Job Ref: 25255

s92 Response – Te Karaka –, LR-2026-113441-00, LV-2026-113442-00, LL-2026-113442-00 & WS-2026-113444-00

Project Te Karaka Stopbank Upgrade Project

Subject Response to Pine Hollow Family Trust submission matters relevant to road raising, access and drainage design

Fig. 5: (Shelter hedge removed) Summer solstice sun study finding shadow from stopbank reaches edge of the building at approximately 7:00 p.m. on the summer solstice.

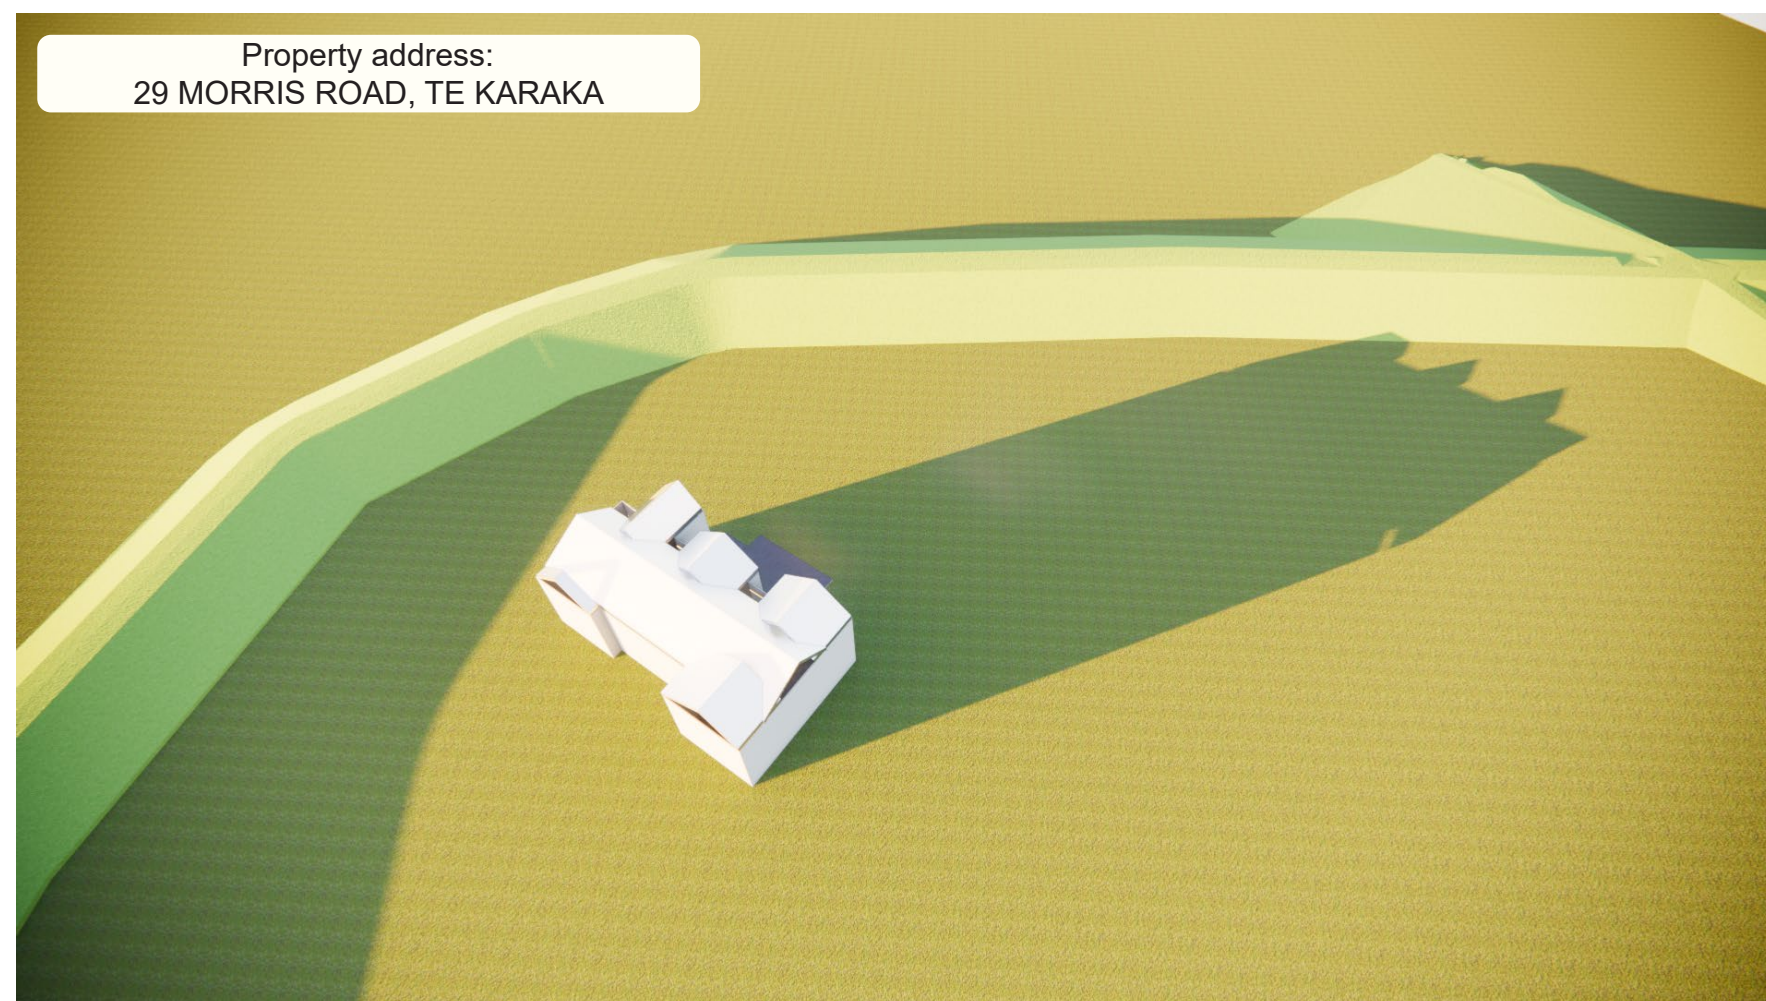
- Clarify effects as a result of adjustments to existing electrical infrastructure, particularly with regard to neighbouring properties;
- Clarify any effects of shading to properties as a result of the height increase of the existing stop bank or proposed stop bank;
- A review of any adverse visual amenity effects for the following properties:
 - o 9 and 11 Rangatira Road;
 - o 29 Morris Road;
 - o 59 Kipling Road; and
 - o 54 Kipling Road

During the summer solstice, the stopbank would cast shadow onto the southern side of the dwelling from approximately 7:00 pm, with no shading effects on the outdoor living area (Refer Appendix A: Figure 5). The shelterbelt would similarly only affect the western side of the dwelling during the late afternoon. Given the timing, extent, and limited overlap with the principal outdoor living areas, the shading effects associated with both the stopbank and shelterbelt during summer are considered to be Very Low to Negligible.
